DESIGN REVIEW/CERTIFICATE OF APPROPRIATENESS APPLICATION

PROPERTY INFORMATION						
Project/Property Address:				Project Name/Business Name:		
611-659 Eastgate Parkway			Eastgate Commercial Park - Phase 2			
Parcel #: Zoning: (see <u>Map</u>) OCT]	Acreage: 2.33 Phase 2 (7.49 Original)		
PLAN SPECIFICATIONS						
Application Type: (check all that apply) ■ Site Plan Landscaping		Building Design Demolition Olde Gahanna only				
Project Description: Modification to the original approved site plan layout only. Replacing the the 2 (8,520sf) proposed buildings along the west side with a single (16,800) building in the same location. Slight parking/pavement modifications to match alignment of single building. No other items from the original approved plan/application have been modified or changed.						
		APP	LICANT II	VFORMATIO	N	
Applicant Name (Primary Contact): Re	obert Leveck			Applicant Address: 625 Eastgate Pkwy, Gahanna, Ohio 43230		
Applicant E-mail: rleveck@leveckcons	struction.com		***************************************	Applicant Phone: 614-582-4765

2022 EASTGATE COMMERCIAL PARK, PHASE II SITE IMPROVEMENT PLANS

643 THROUGH 657 EASTGATE PARKWAY THE CITY OF GAHANNA

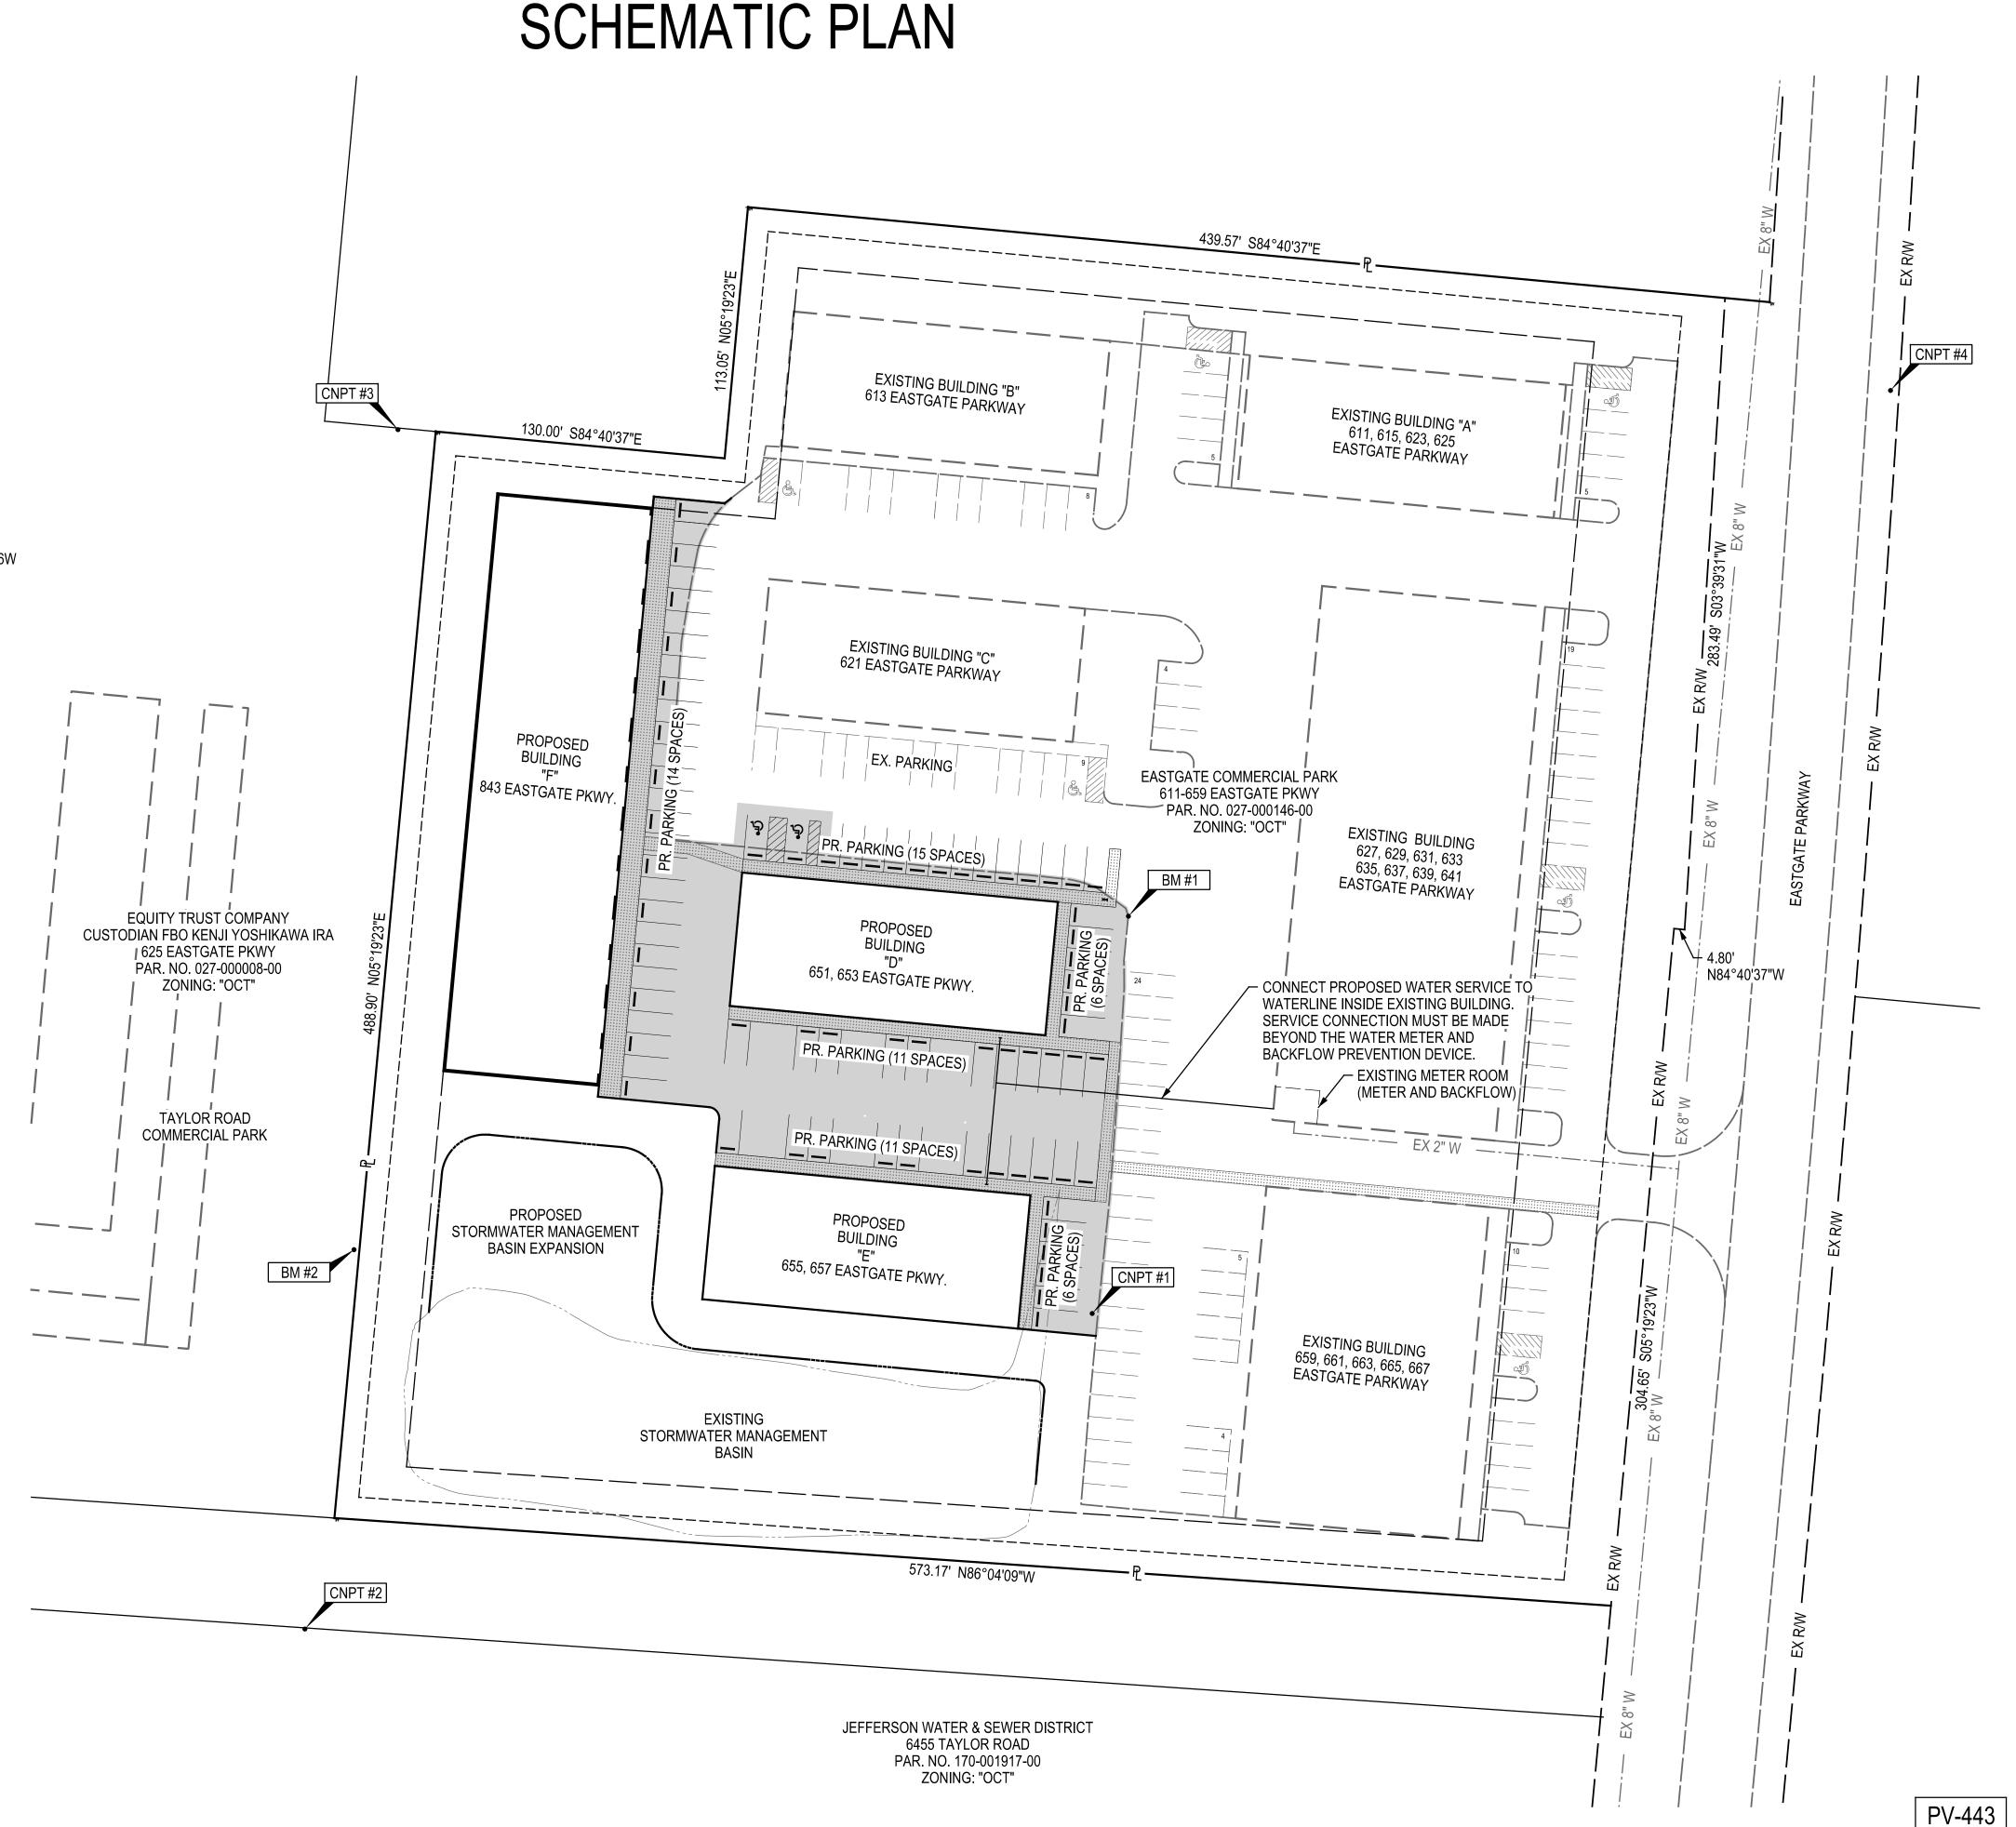
- 2. Per Section 1163.08, the landscape plan needs to calculate the parking area (spaces and drive aisles). The square footage of required landscape islands is 5% of the parking area. 1 tree per 100 square feet of required landscape island is required. The minimum tree caliper size is 3". The submitted landscaping plan shows the previously approved building layout not the proposed layout with the large 18,200sqft building. Update the plan to reflect the new layout.
- 3. Chapter 914 requires one tree inch to be planted per 1,000 square feet of impervious surface. This requirement is in addition to any other planting requirements. The submitted landscaping plan shows the previously approved building layout not the proposed layout with the large 18,200sqft building. Update the plan to reflect the new layout.

5. I found an issue with Submittal 2 for 611-659 Eastgate Parkway. The back building 643 Eastgate Parkway (parallel to property line) is over 1000 feet from the closest fire hydrant. An additional fire hydrant(s) is required. Fire hydrant has been added on the south end of this building via an extension from the neighboring development, with an easement. As shown on the revised plans.

tree planting

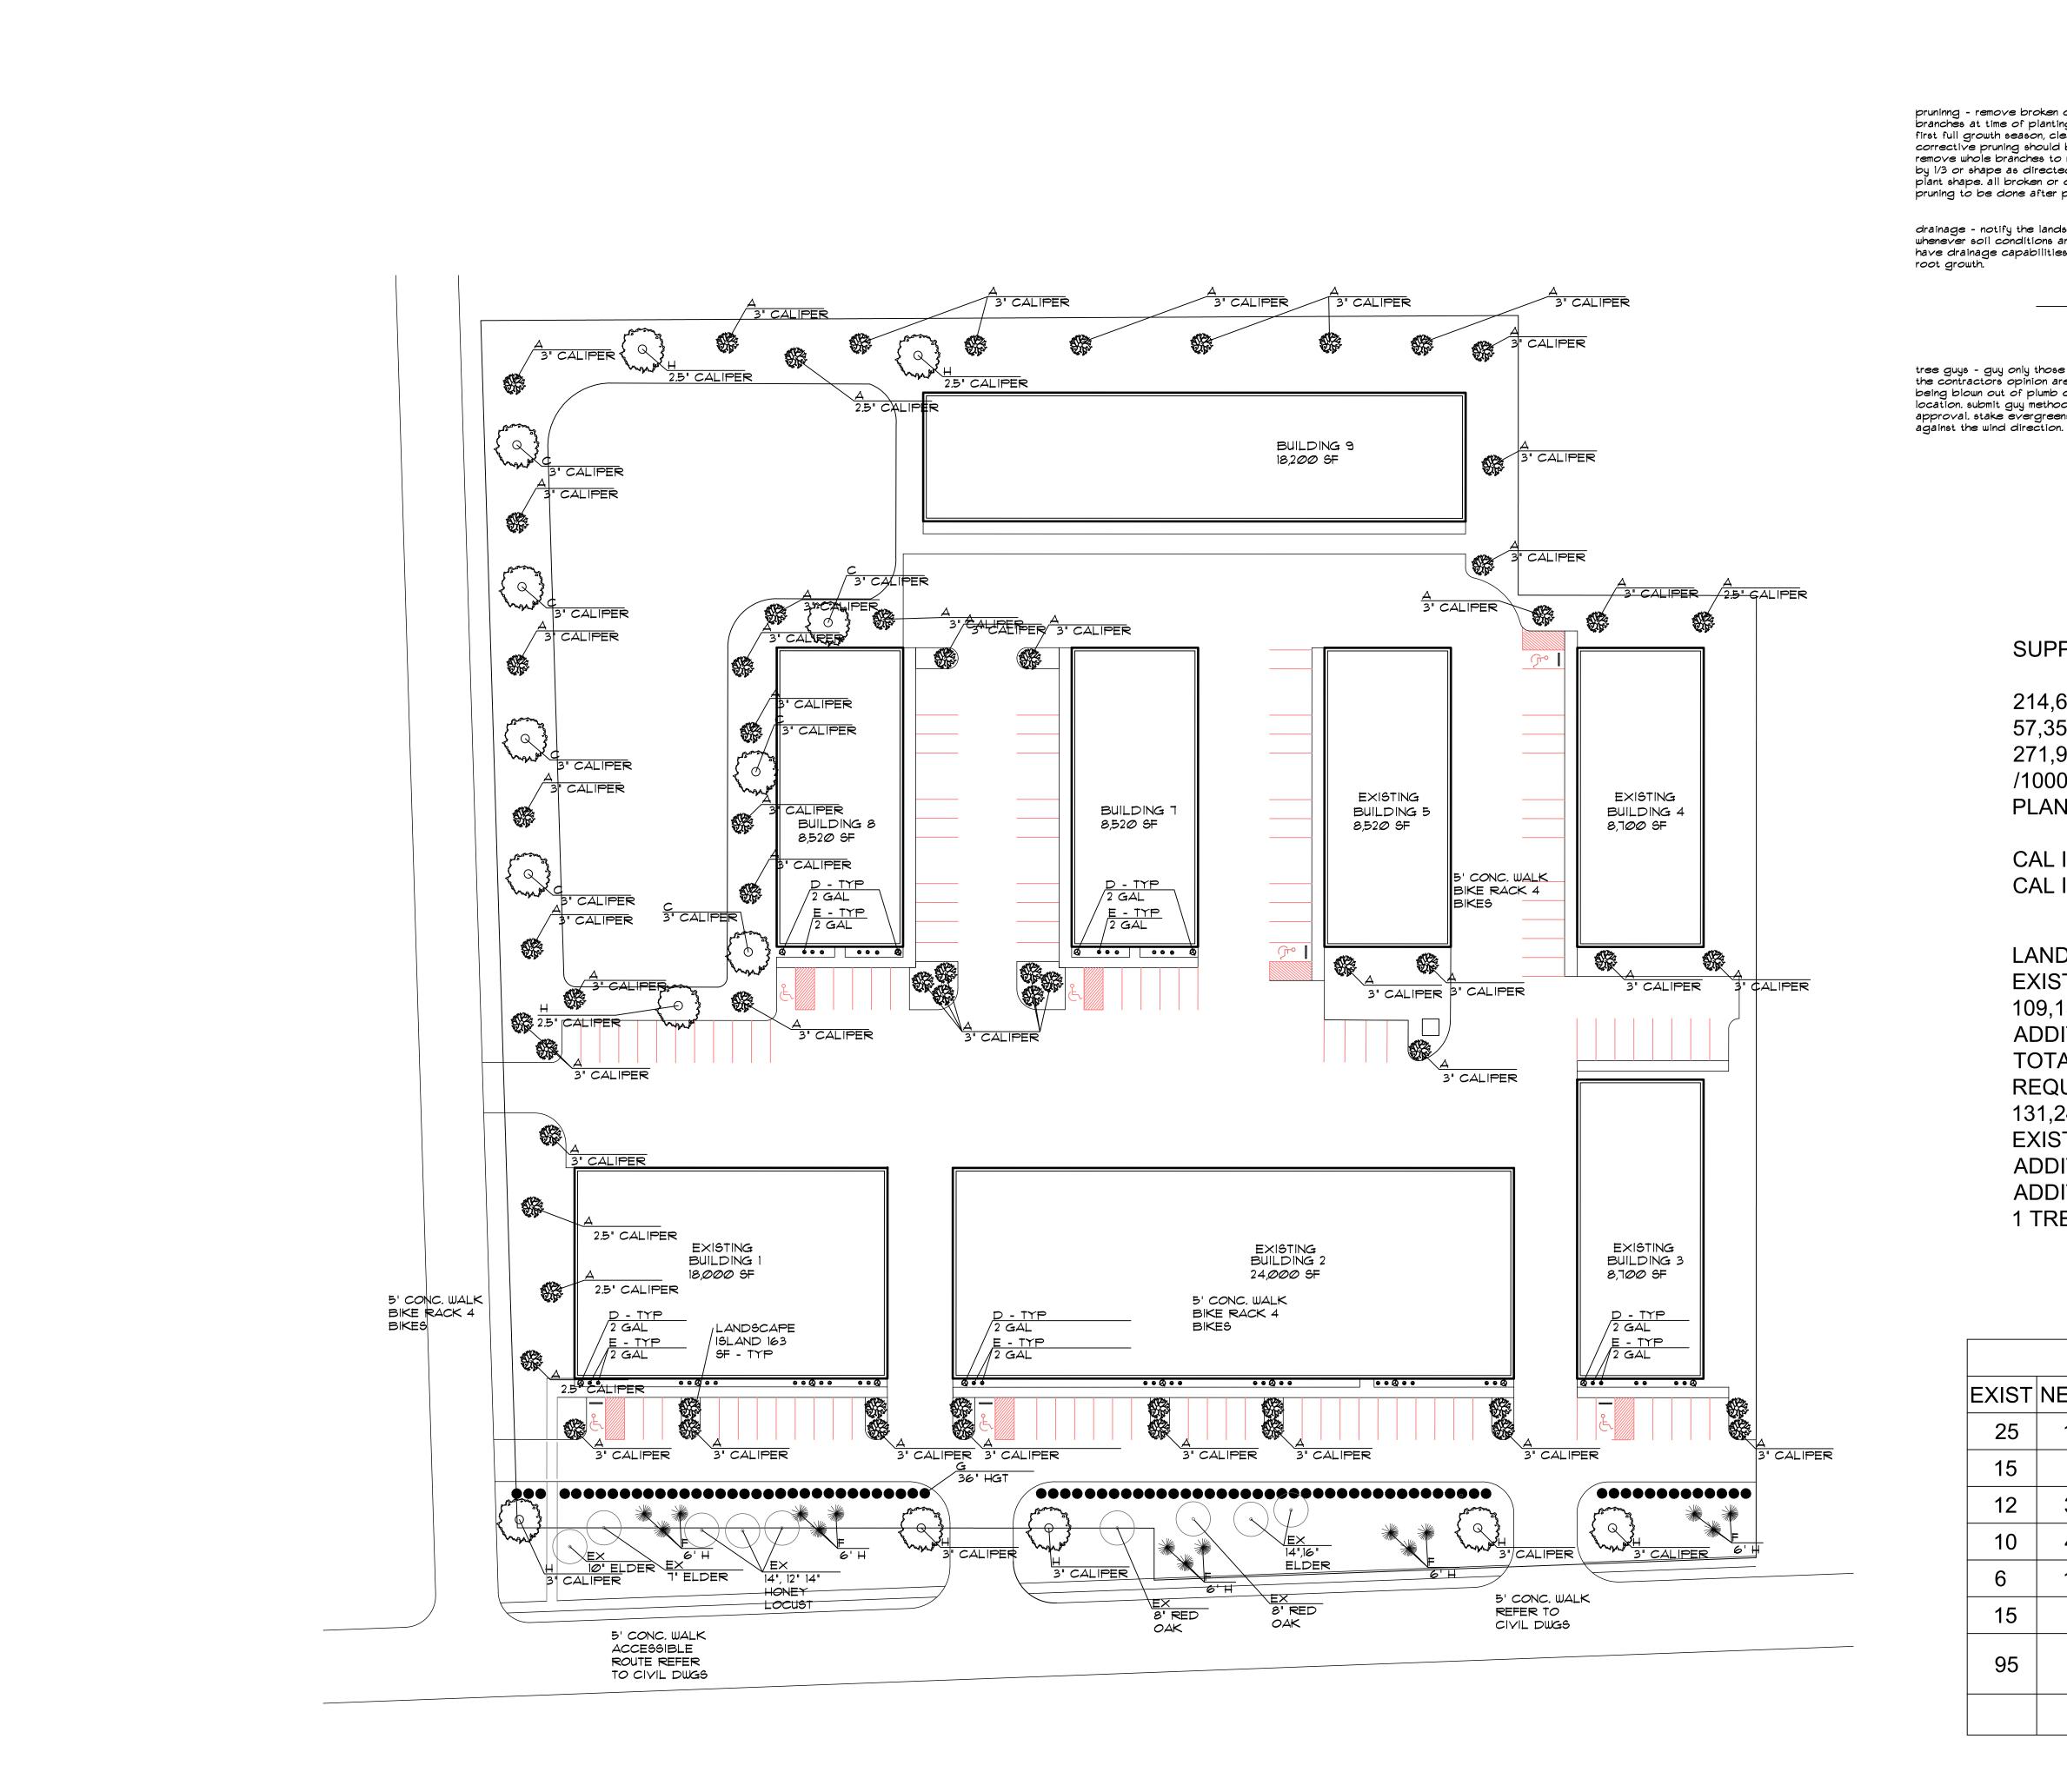
4. Tree planting specifications are not entirely appropriate. Pruning should only take place at planting if branches are broken or damaged. Corrective pruning and clearance pruning should be delayed until a full season of growth. At least the top 1/3 of the burlap should be cut away. Root flare should be planted even with finished grade. Trees should not intentionally be planted 2" above nursery height. Mulch should be pulled away completely from trunk. Landscaping plans have been updated accordingly.

Prunis cerasifera 'Newport' and Malus spp. are both very susceptible to a variety of pests and diseases. Alternative species should be considered to replace these trees. Maple species is still not identified on the landscape plan. The maple family is large, and the species in the family range on size and a number of other features.

Landscaping plans have been updated accordingly.
